**PHOENIX SKY HARBOR INTERNATIONAL AIRPORT
TERMINAL 4 SOUTH 1 CONCOURSE CONCRETE APRON
AIP NO. 3-04-0029-0XX-20XX
DESIGN-BID-BUILD
PROJECT NO. AV08000083 FAA**

ADDENDUM NO. 4

ISSUE DATE: September 11, 2020

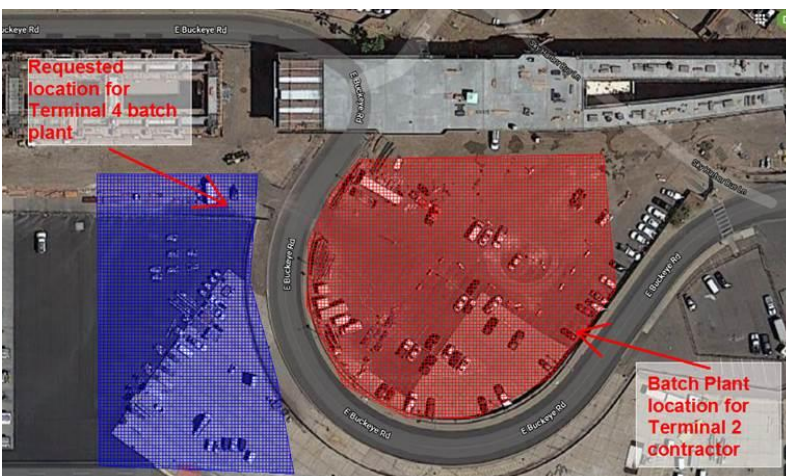
Q2: *At this time the contractor for terminal 2 apron construction has a batch plant located on East Buckeye Road near gate 220. We believe that two batch plants can fit in contractor yard location (please review drawing). To allow contractors to have a competitive and equal opportunity to bid the terminal 4 apron construction, will the area located in blue on the drawing be available for a batch plant location?*

A2: The area in the described location, in its entirety, has been previously allotted to ongoing projects at PHX that extends into the start date of this project. Currently the entire lot is being utilized and has been approved by The Owner and FAA for this use. If the area becomes available the selected Contractor may request to the Owner and FAA for use of this site, but it is not currently designated for use for the Terminal 4 S1 project.
